Access Compliance Report Public Rights-of-Way (Curb Ramps)

Main Street: PINCIAN_WAY Cross Street: APPIAN_WAY Location: SE

ADA ID: RPAT211015143840 Ramp Type: Type 1 - Perpendicular Diagonal Initial Pass/Fail: Pass Overall Compliance: No Severity Score: 22

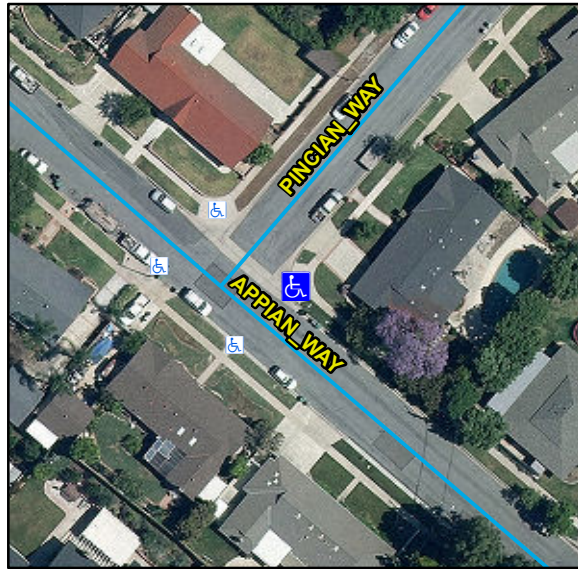
R304.2.2, R204.3, R304.2.1, R304.2.2-Perp, R304.3.2-Para, R304.5.3, R305, STD 1115

Compliance	Description	Data	Compliance	Description	Data
N/A	Ramp Length (in)	129	N/A	Flare Type LT	
Yes	Ramp Width (in)	65			Sloped
Yes	Ramp Run Slope (%)	6.9	N/A	Flare Slope LT (%)	6.7
Yes	Ramp Cross Slope (%)	1	N/A	Flare Traversable LT	No
N/A	Landing Present	No	N/A	Flare Type RT	
N/A	Landing Length (in)	N/A			Sloped
No	Landing Width (in)	N/A	N/A	Flare Slope RT (%)	3.2
No	Landing Run Slope (%)	N/A	N/A	Flare Traversable RT	No
No	Landing Cross Slope (%)	N/A	No	DWS Provided	No
N/A	Landing Movement Obstructed?	No	N/A	DWS Contrast	N/A
	Landing Movement Type	N/A	N/A	DWS Length (in)	N/A
N/A	Landing Shared	N/A	N/A	DWS Full Width	N/A
N/A	Clear Space	Yes	N/A	DWS Offset Left (in)	N/A
N/A	Clear Space To Crosswalk (in)	48	N/A	DWS Offset Right (in)	N/A
N/A	Marked Crosswalk 1	No	N/A	Marked Crosswalk 2	No
	Crossing 1 Direction	N		Crossing 2 Direction	W
	Marked Crosswalk 1 Width (in)	N/A		Marked Crosswalk 2 Width (in)	N/A

N/A	Ramp Inside Crosswalk 1	N/A	Yes	Ramp Inside Crosswalk 2	N/A
	Crossing 1 Slope (%)	3.3		Crossing 2 Slope (%)	6.6
	Crossing 1 Cross Slope (%)	2.1		Crossing 2 Cross Slope (%)	0.5
Yes	Gutter Ponding	No	No	Curb Slope	11.5
Yes	Gutter Lip Height (in)	0		Road Run Slope (%)	0.9
Yes	Gutter Run Slope (%)	3		Road Cross Slope (%)	1.1
Yes	Gutter Cross Slope (%)	0.3			
Yes	Overall Surface Condition: Acceptable		No	Perp Joint Present	No
	Cross Gutter Present?	Yes		Spandrel Present?	Yes
	Replace Cross Gutter?	No		Replace Spandrel?	No

Remove & Replace Curb Ramp With Two New Directional Ramps or Equivalent.
